California High-Speed Rail Authority

RFP No.: HSR 13-57

**Request for Proposal for Design-Build
Services for Construction Package 2-3**

Book IV, Part G.1 – Design Variance Report

**CALIFORNIA HIGH-SPEED TRAIN PROJECT
FRESNO TO BAKERSFIELD**

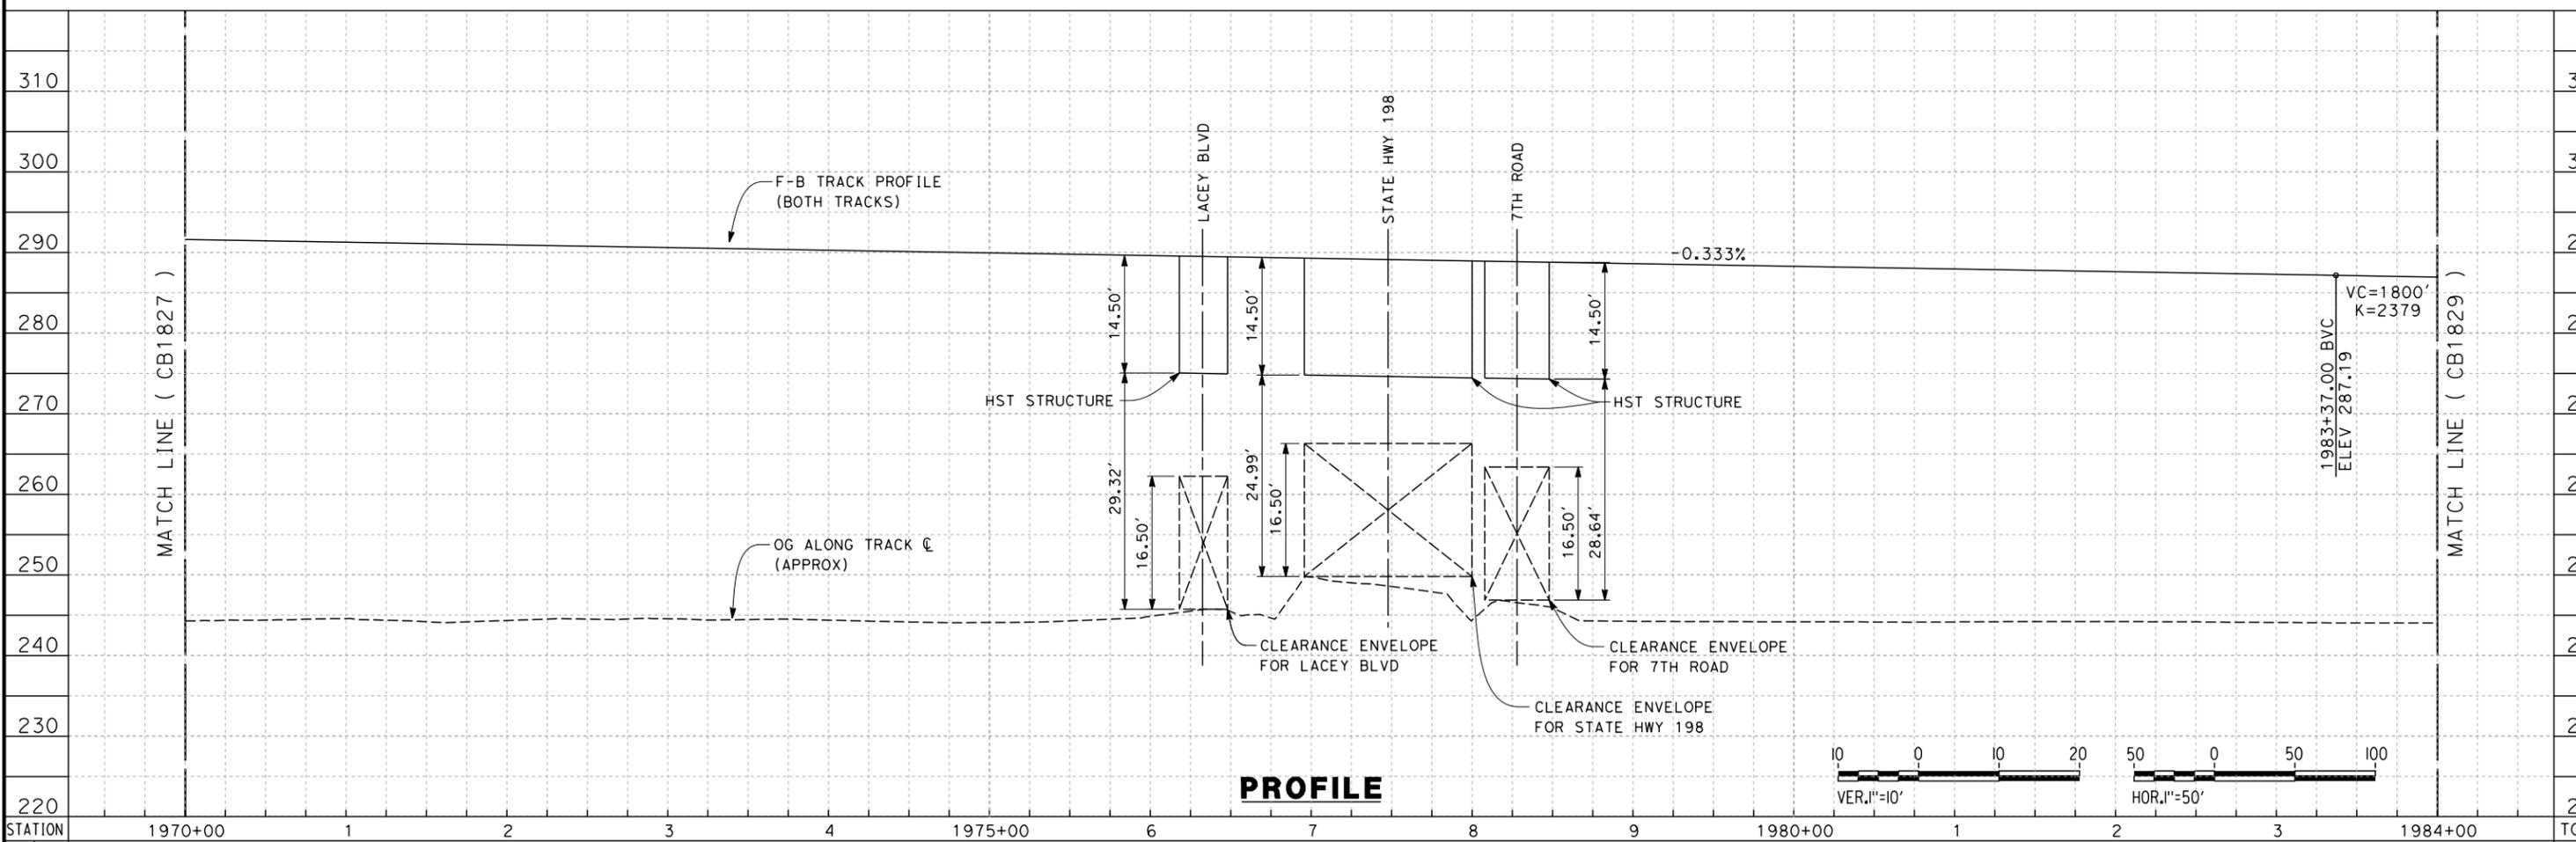
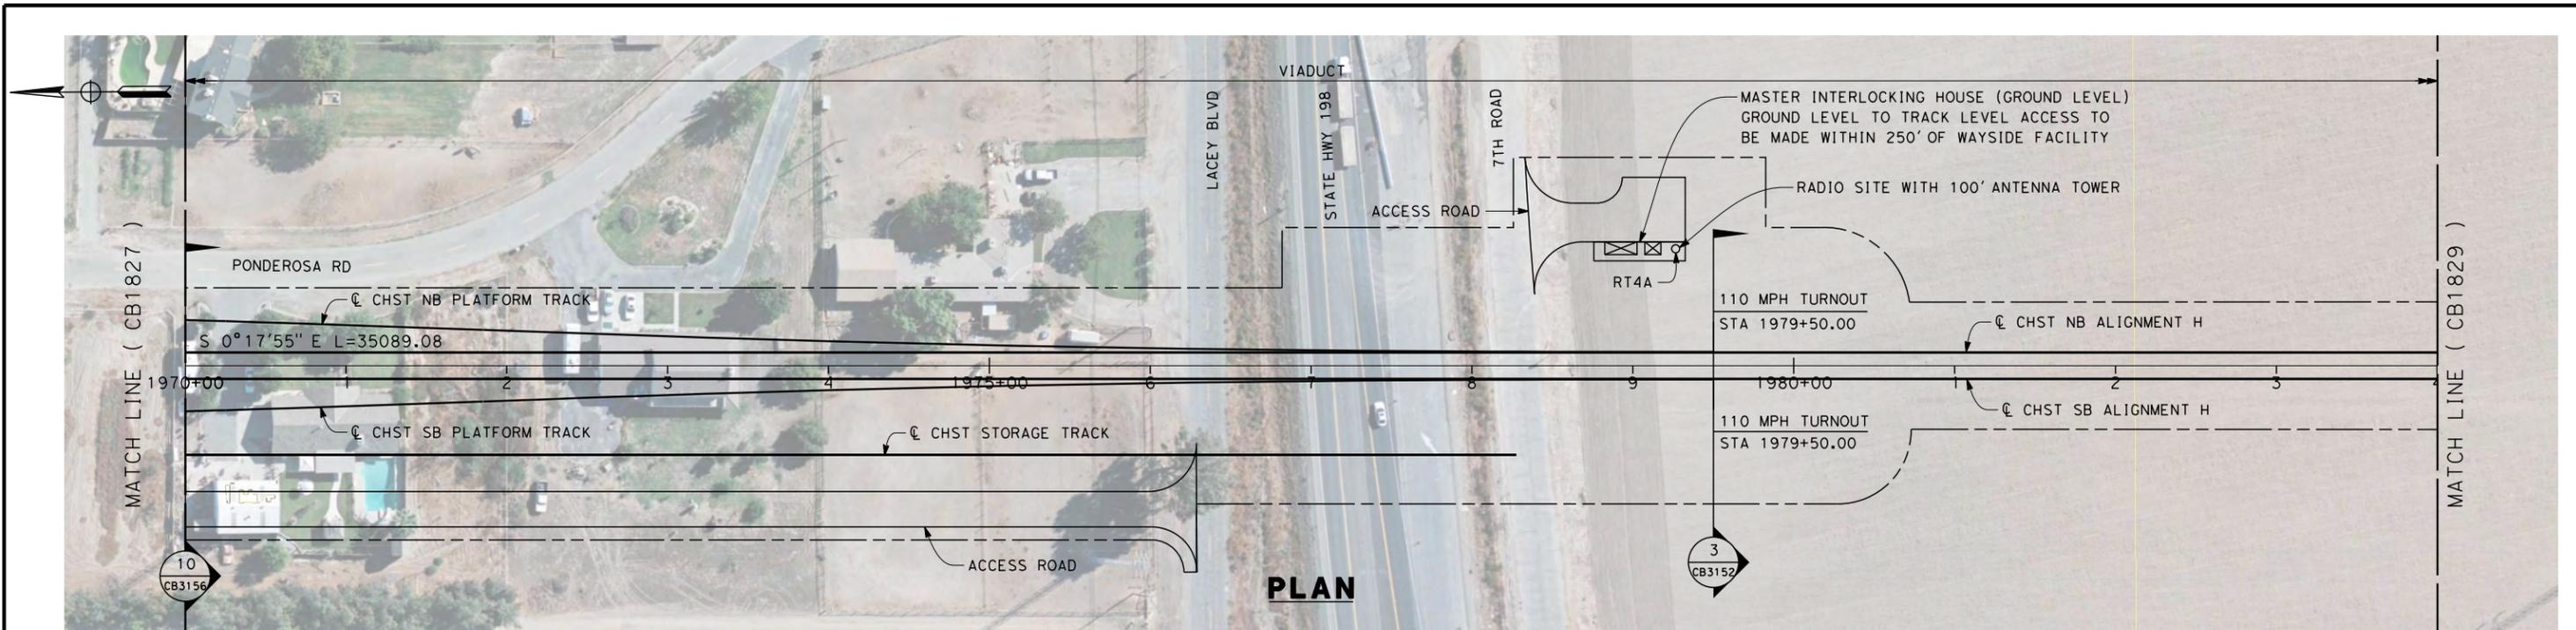
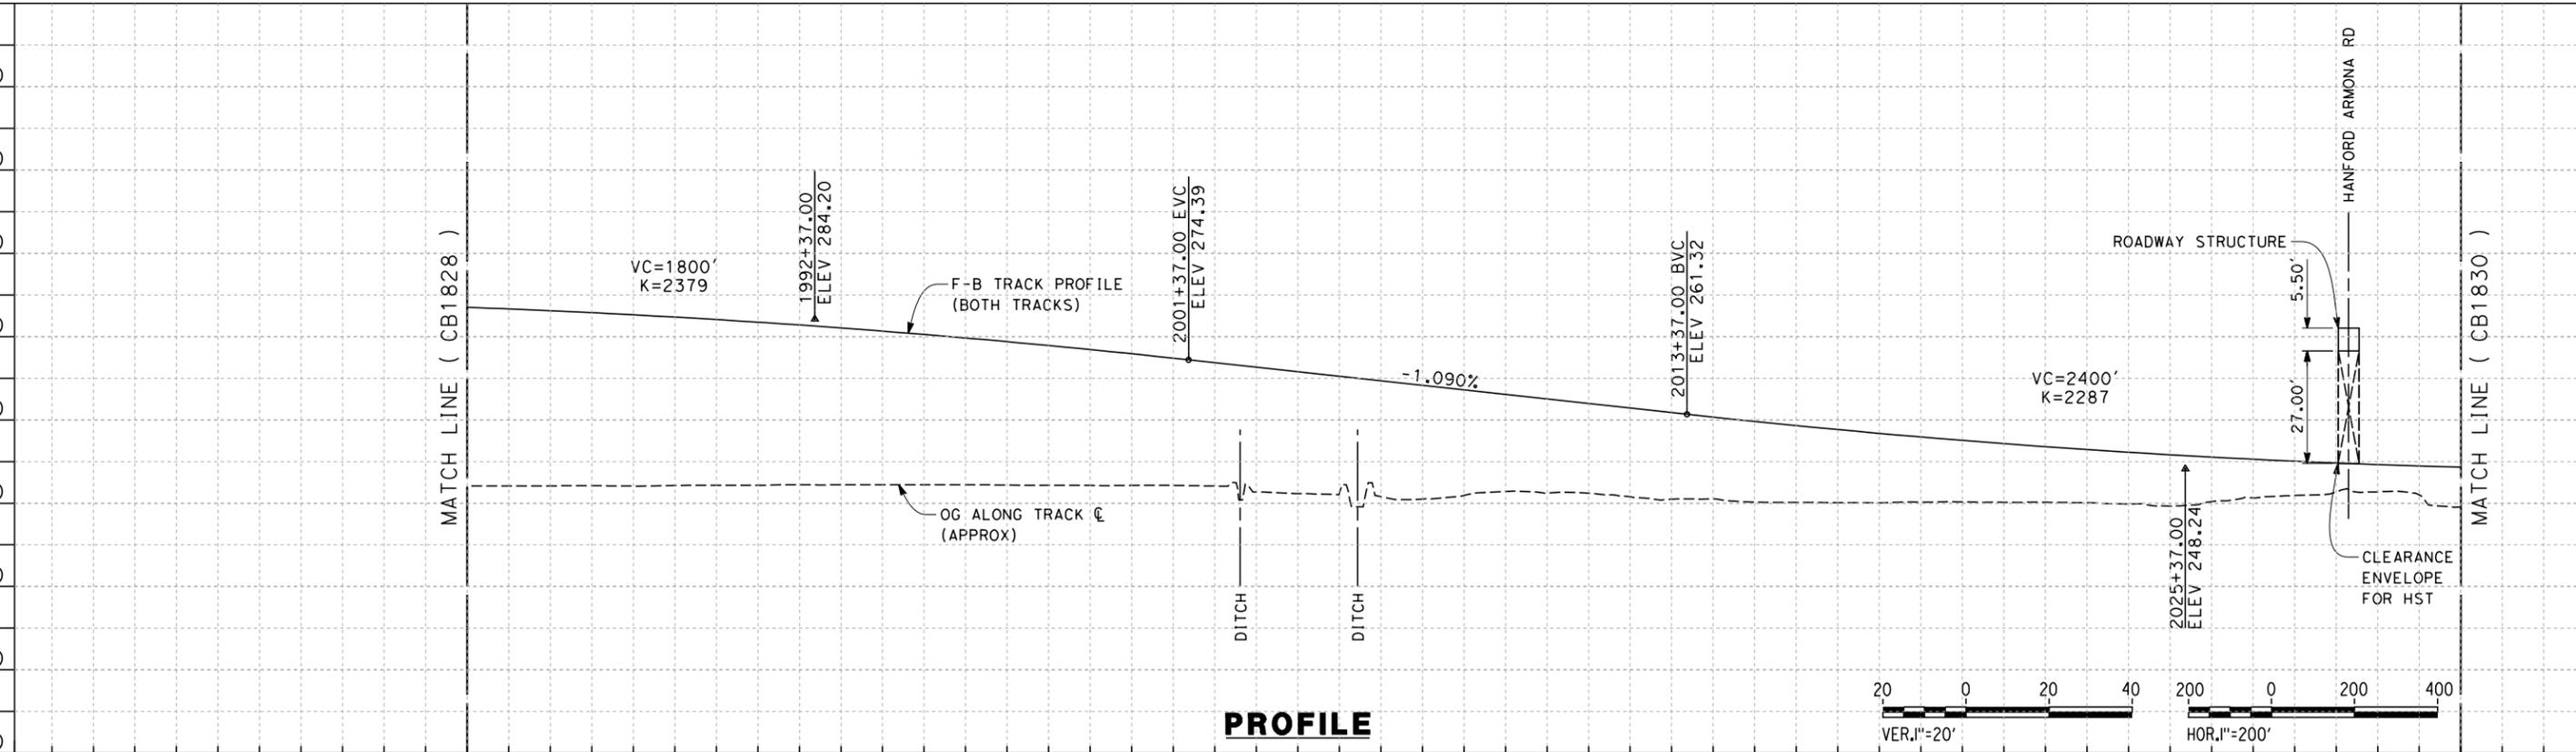
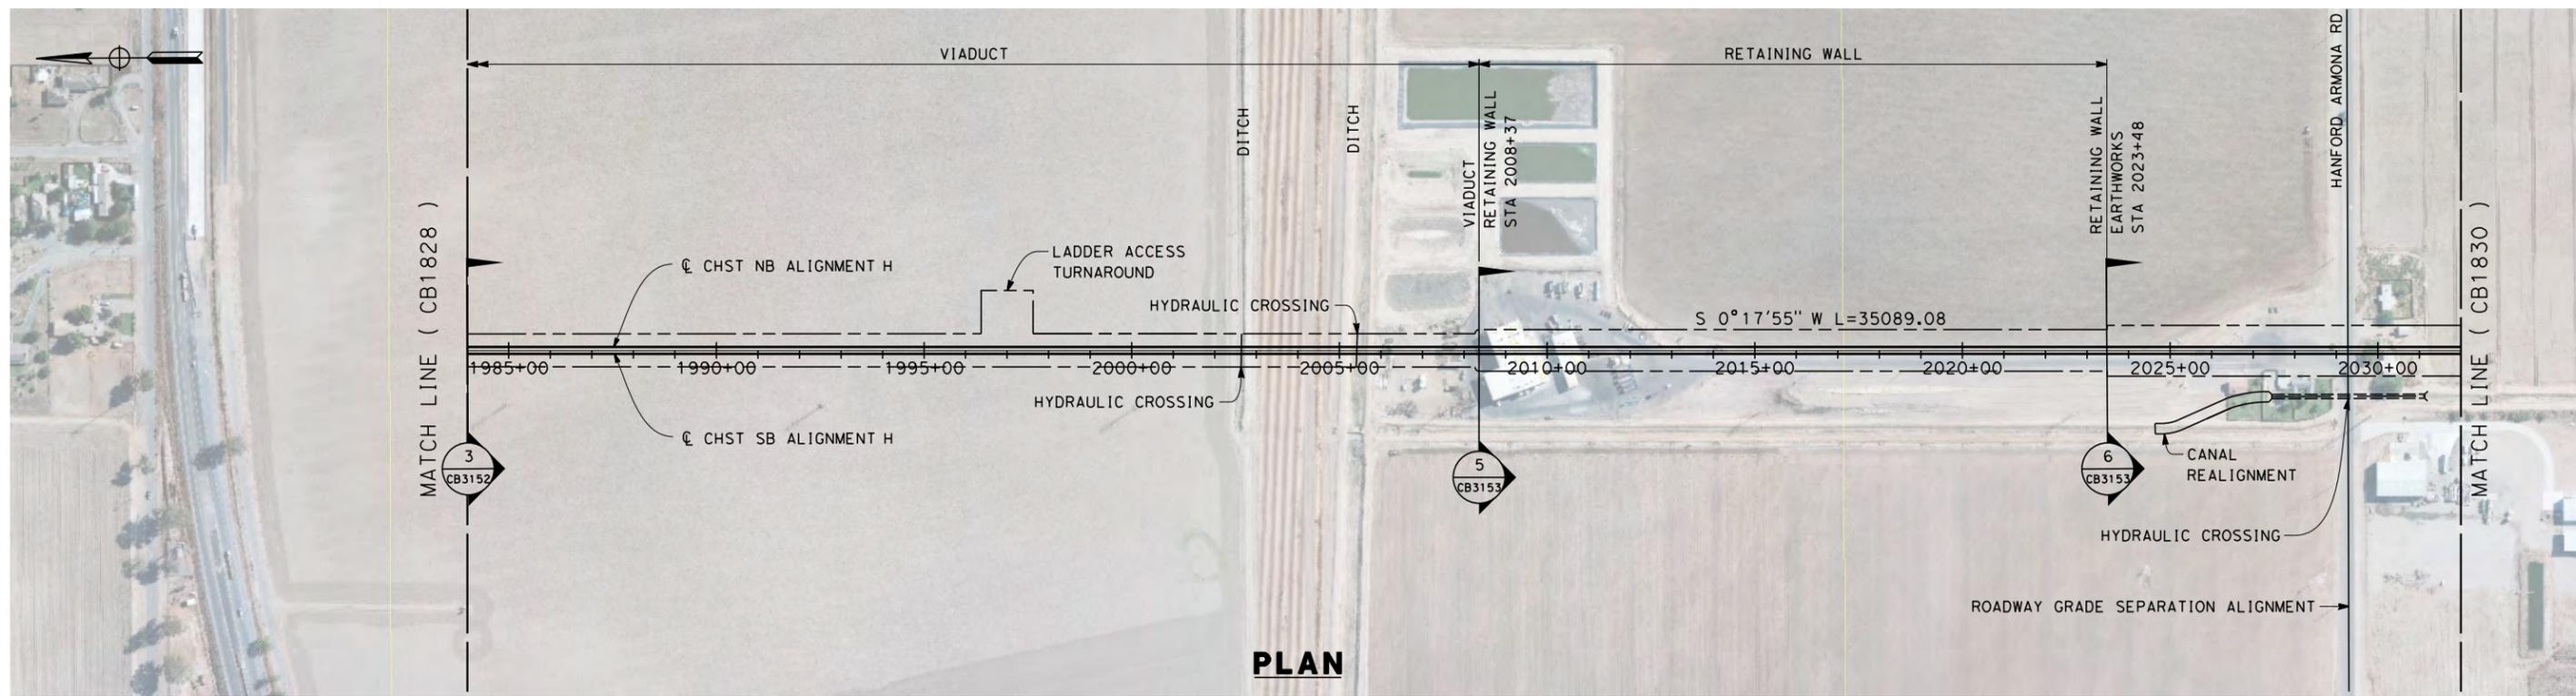
<p>REASON FOR REQUESTING A VARIANCE</p>	<p>The horizontal spiral in the return curve of the 110 mph turnout is coincident with the beginning of the vertical curve of the station tracks at all four quadrants. This does not provide the exceptional 1.5 seconds of attenuation time (242 feet) indicated in TM 2.1.2 Section 6.1.1 or the minimum 100 feet called for in TM 2.1.2 Section 6.1.7.</p>
<p>JUSTIFICATION FOR VARIANCE</p>	<p>Kings/Tulare Regional Station is raised on a viaduct and requires vertical curves north and south of the station to lower the tracks back to grade. The vertical curves are on the mainline between the turnout for station tracks and the platforms. This allows for appropriate attenuation length on the mainline and a 0% grade throughout the station.</p> <p>The 15% Record Set design provides the standard 6,000-foot station tracks at 110 mph (from point of switch to point of switch). For this length the</p>

<p>approaching the station would need to reduce speed earlier due to the turnout's location farther from the station. A design variance to Directive Drawing 2.1.3 – Interlock A would be required for the nonstandard position of the station turnouts.</p> <p><u>South of the Station</u> Desirable attenuation can be provided between the return curve spiral and the vertical curve of the station tracks south of the station by sliding the station track turnouts 610 feet south. The mainline vertical curve south of the turnouts would achieve the minimum length (1,200 feet), and the four-track viaduct would require lengthening by 610 feet. The shift south would also require relocating one system site and lengthening the access road. The distance between the station turnouts and station crossovers would decrease by 610 feet.</p> <p><u>North of the Station</u> Desirable attenuation can be provided between the return curve spiral and the vertical curve of the station tracks north of the station by sliding the station track turnouts 388 feet north. This would require lengthening the four-track viaduct by 388 feet. The shift north also requires relocation of a systems site and lengthening of the access road.</p>

OPERATIONS	None identified
MAINTENANCE	Slab track could be used to mitigate maintenance concerns of providing the station track spiral coincident with the beginning of the vertical curve.
INFRASTRUCTURE	None identified
RAILROAD SYSTEMS	None identified
OTHER	The vertical curve was located coincident with the station track spiral to avoid introducing a segment shorter than the length required to provide minimum attenuation. Ride quality may also be reduced; however, designing the two elements coincident allows the horizontal and vertical moves to occur simultaneously.
